Re: ICOM Incorporated

FCC ID: AFJ262700

In reply to your recent questions:

450 MHz verification dipole

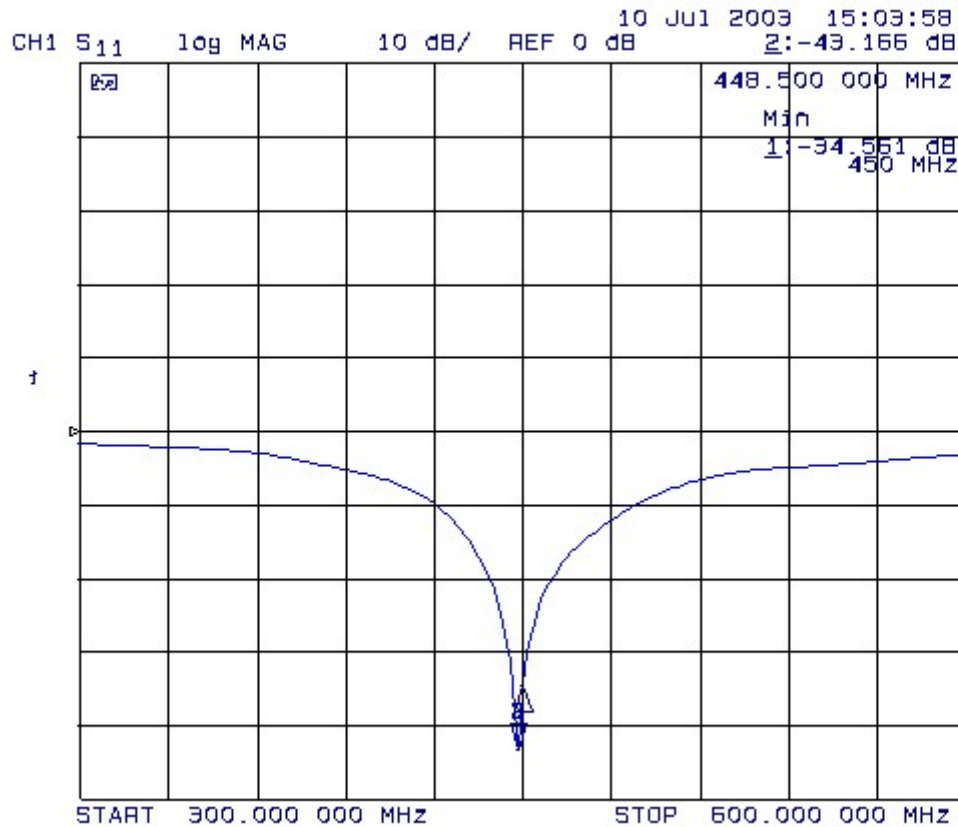
10) Please provide further information regarding the reference dipole (i.e. manufacturer, model, serial, etc.). Also, please provide a plot of return loss data for the dipole used. Is original manufacturer calibration information available?

A10) The reference dipole was manufactured by UltraTech Labs. according to the guideline on Annex G in IEEE P1528/D1.2, April 21, 2003 standard and Table on pp 47~48 in OET 65 supplement C edition 01-01. Refer to the attached plot of return loss for the dipole used.

Manufacturer : UltraTech Labs.

Model Number : W450

Serial Number : UT-VDP-002-052003
